Re: National Trust submission on SSDA32766230 for 35-75 Harrington Street, The Rocks

Proposed Development

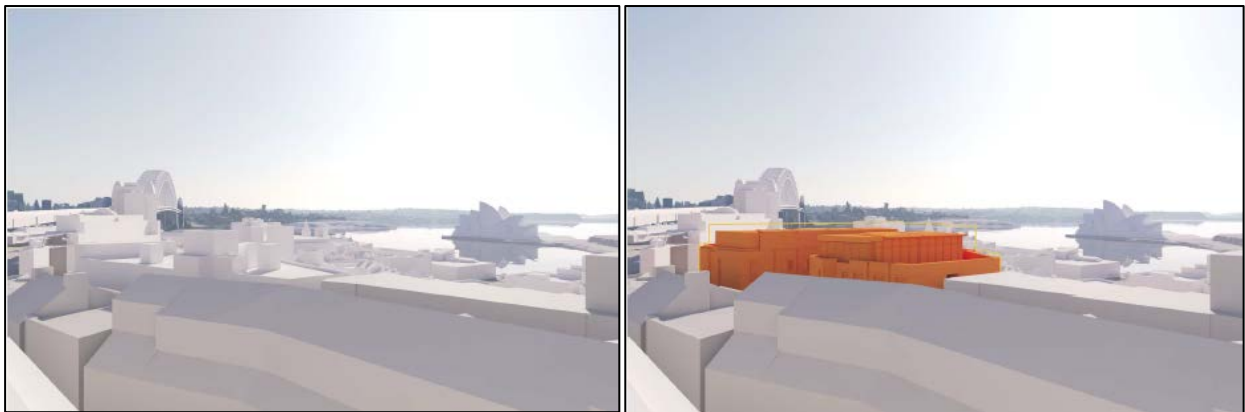
We fail to understand how any view in The Rocks, a statutory heritage conservation area of state heritage significance, can be considered to have “no significance”. The Trust strongly assert that the views within, into

and out of the conservation area are extremely significant and the VIA fails to acknowledge and assess this. It additionally fails to consider the views from all key heritage viewpoints that may be affected by the proposal.
